## SCHOOL TOWN OF HIGHLAND G.O. BOND 2022 PROJECTS Highland, IN 46322

# ADDENDUM NO. 2 MARCH 8, 2023

# PREPARED BY SCHMIDT ASSOCIATES FOR: GO BOND 2022 PROJECTS HIGHLAND, SCHOOL TOWN OF

CL101.2

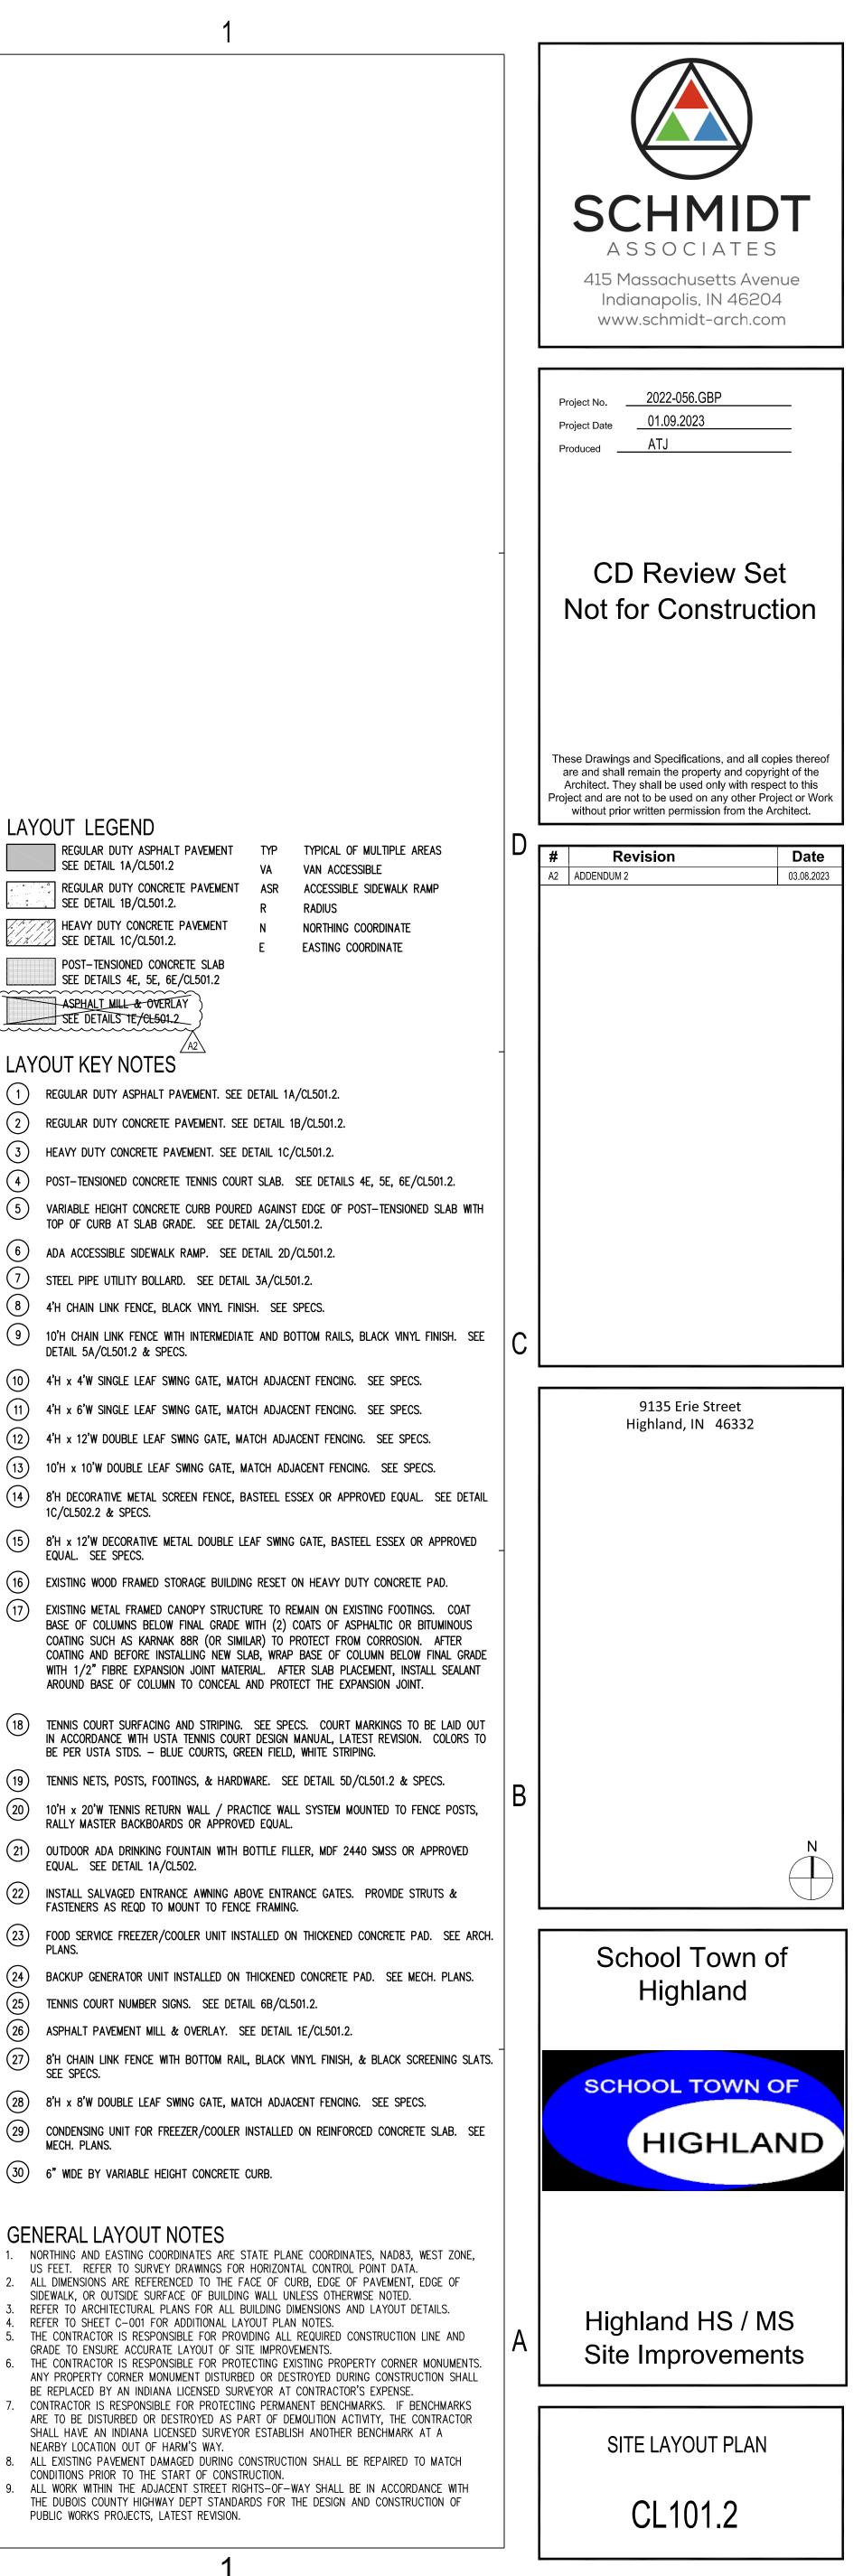
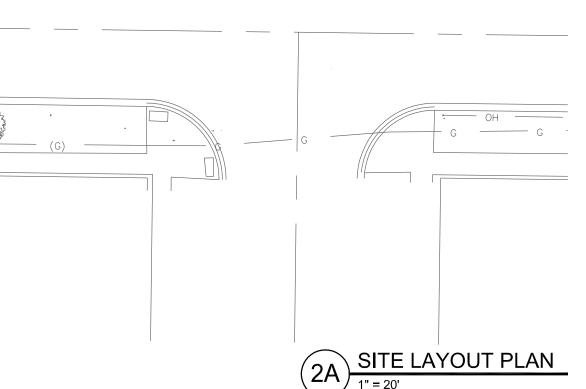
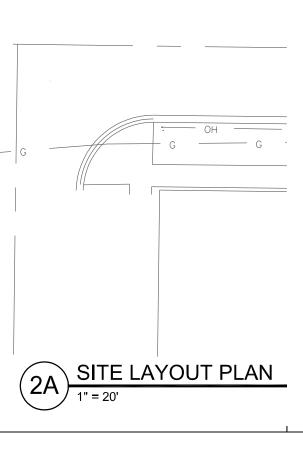
- Question: Drawing CL 101.2 Layout key notes 23 and 27 may need some additional clarifications. The drawing is showing note 23 as a freezer/cooler unit installed on a thickened slab. There are 5 places where this is shown. Item 27 on the drawing is not listed on the keynotes. Response: These Keynotes are clarified. See Addendum 2

- 2. The Layout Legend on Sheet CL101.2 shows two notes with the same hatch pattern. Details 4E, 5E, 6E on CL501.2 (referenced in the first of two similar hatch patterns) here show stone, fine aggregate, 10 mil poly and reinforced concrete slab over "Existing Asphalt Tennis Courts". Detail 1E (referenced in the second of two similar hatch patterns) shows existing asphalt being milled to 1.5" depth and a new HMA surfacing being placed over existing. Please clarify the intent at the existing tennis courts. Is milling and resurfacing the existing tennis courts necessary if we are installing stone over the top of it? Response: There is no mill/overlay at tennis courts. The existing asphalt pavement either remain or is removed to full depth. The mill/overlay note is deleted from the Legend. See Addendum 2.

- 3. See sheets CD101.2 demo note 17 which indicates to remove fence, posts, and gates with footings to remain. See sheet CL101.2 which calls out notes 23 & 27 for the fence that would be installed where demo'd by note 17. Note 23 does not relate to fence installation and note 27 is not found on the plan. There also appears to be some other note callouts on sheet CL101.2 which are erroneous or do not relate to the work being called out. Please provide revise notes in this area to reflect work being completed.

- a. Additionally are the footings for fence posts noted with 17 on CD101.2 intended to be reused for new posts or abandoned in place?

Response: The existing tennis court fencing around the perimeter of the courts to be removed including the footings. The existing interior tennis court fencing running north-south to be removed including the footings. The existing interior tennis court fencing running east-west to be removed but the footings can remain with the posts cut off at grade; however, the new east-west interior fence is about 9" south of the existing east-west fence so there may be conflicts between the existing fence footings and the new fence post installation depending on location. Any fence post footings scheduled to remain that are not in conflict with new work may be abandoned in place.
